Transmittal
Revision Inserts
Final Status Survey Report
Adjacent Land Area
Kaiser Aluminum & Chemical Corporation
Tulsa, Oklahoma

FIGURE 3-3
FINAL STATUS SURVEY REPORT
FINAL SURVEY UNITS
ADJACENT LAND AREA REMEDIATION
KAISER ALUMINUM
TULSA, OKLAHOMA

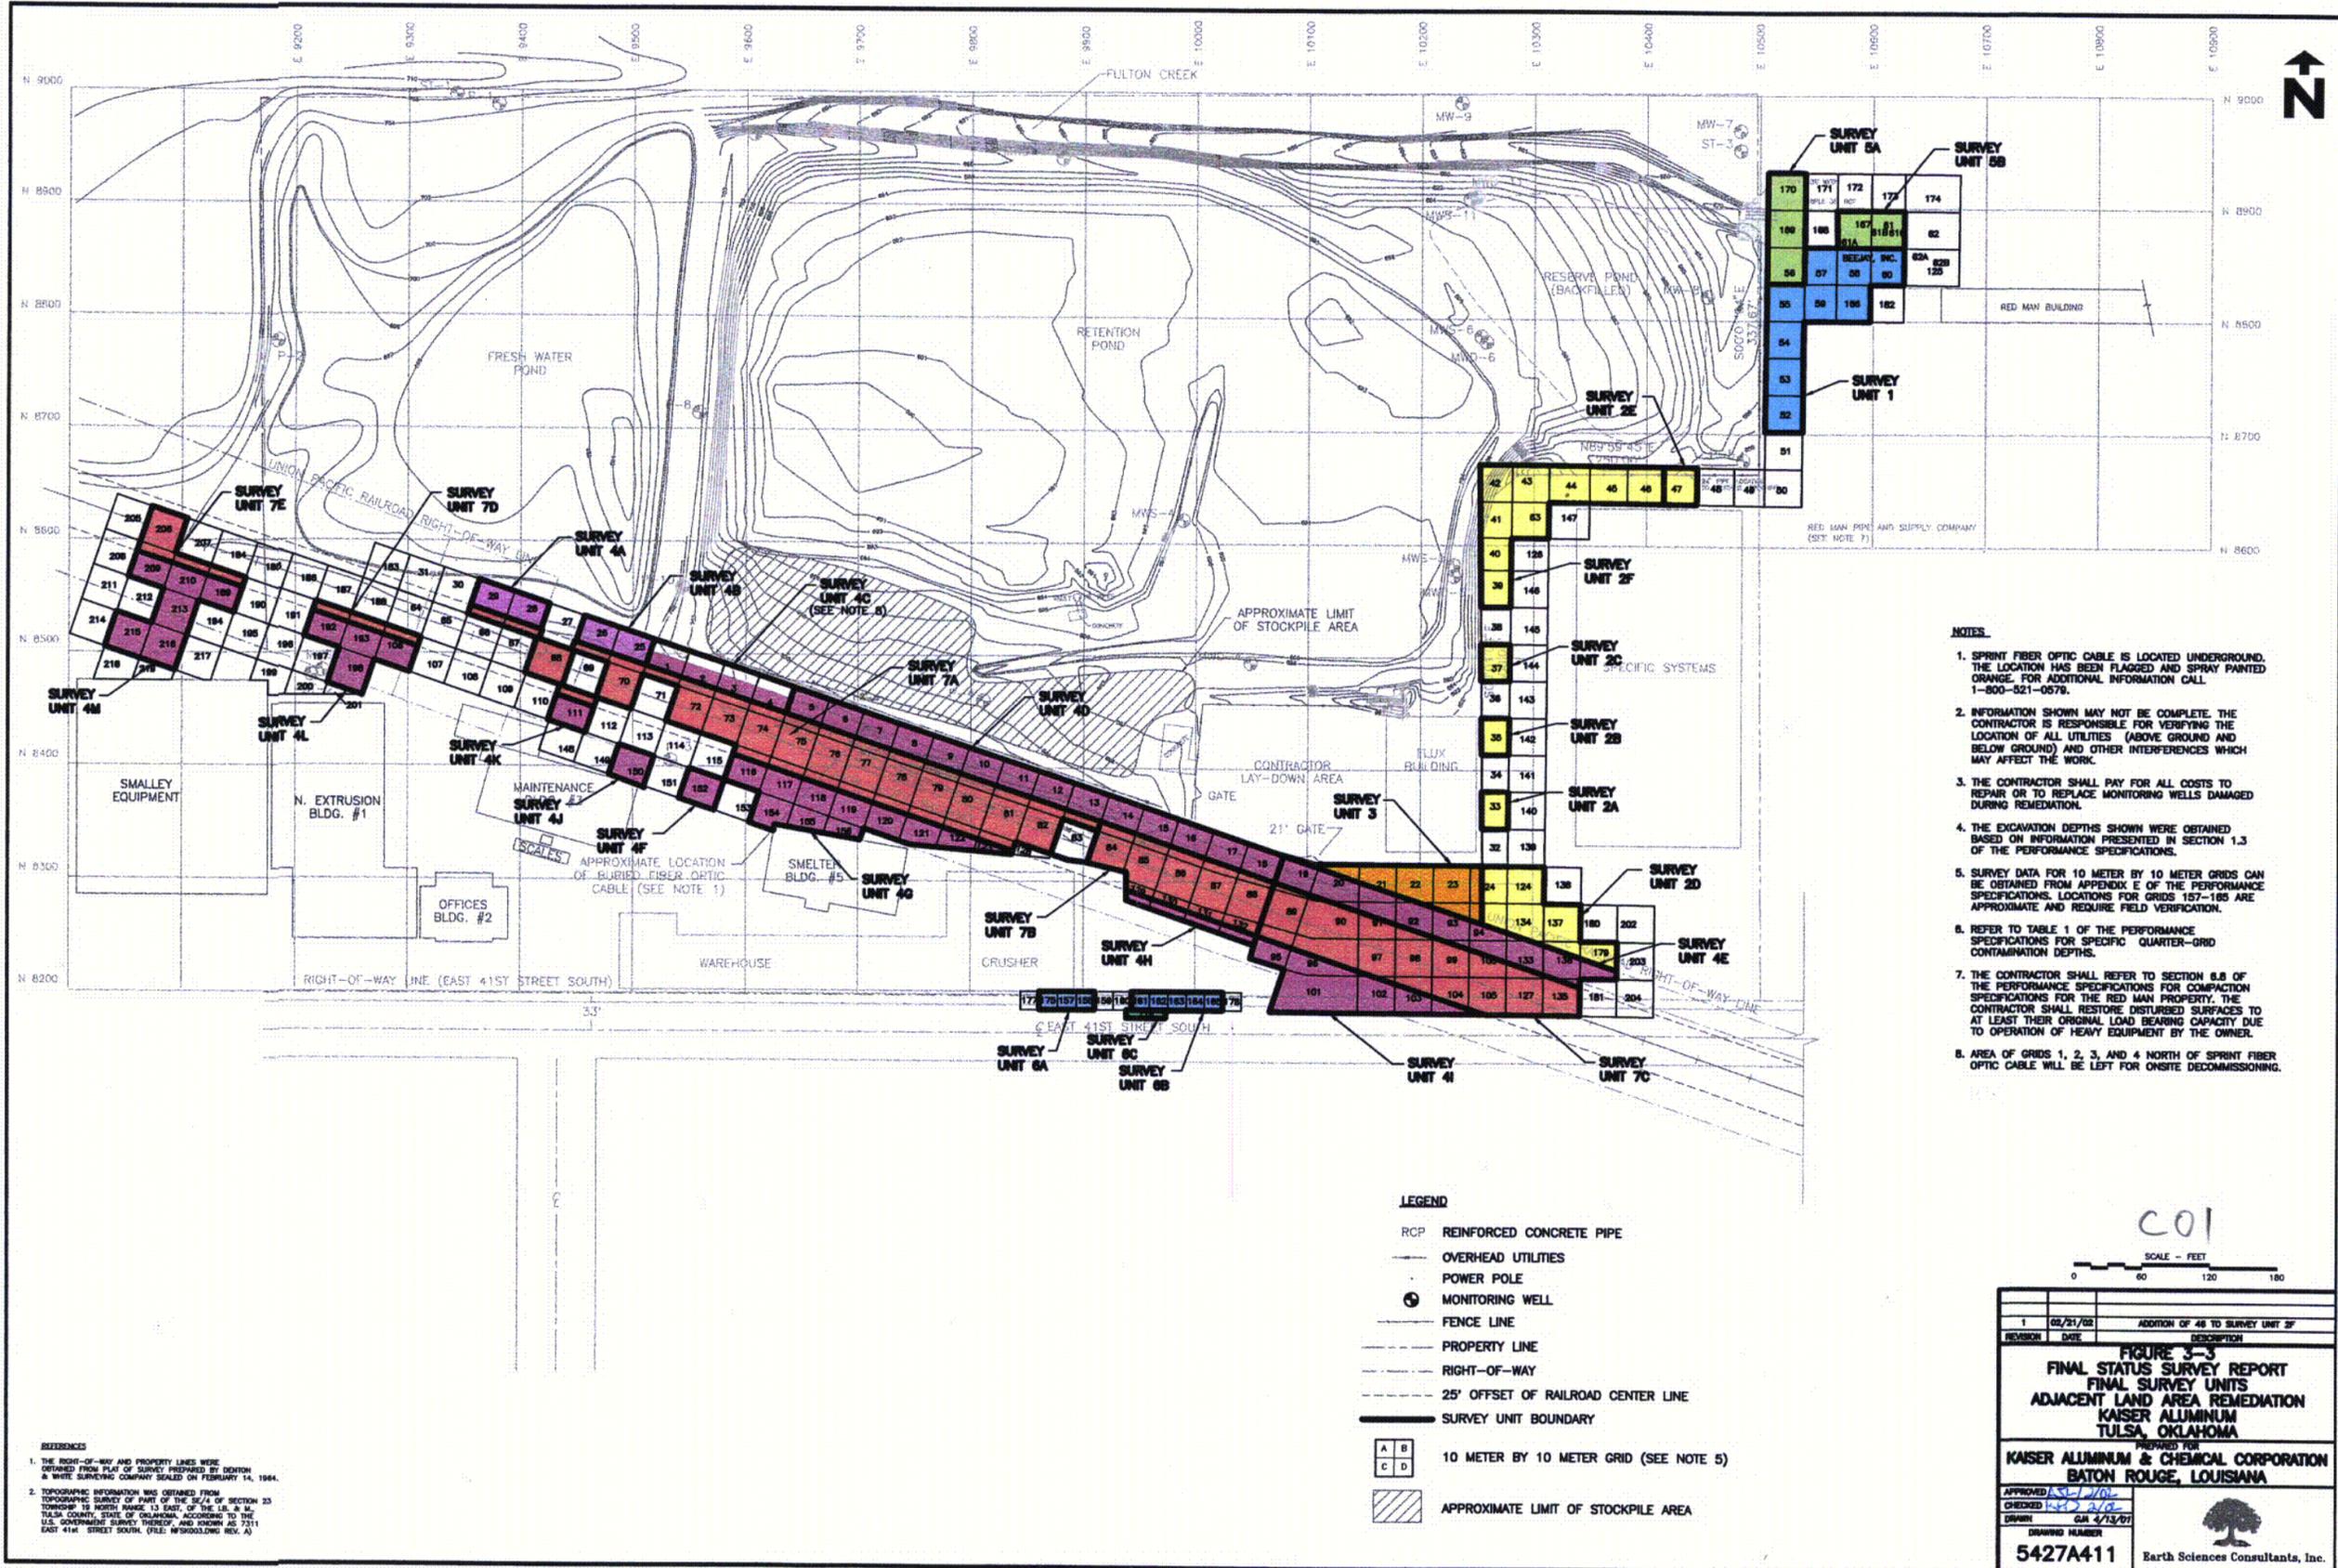
1	02/21/02	ADDITION OF 46 TO SURVEY UNIT 2F
REVISION	DATE	DESCRIPTION
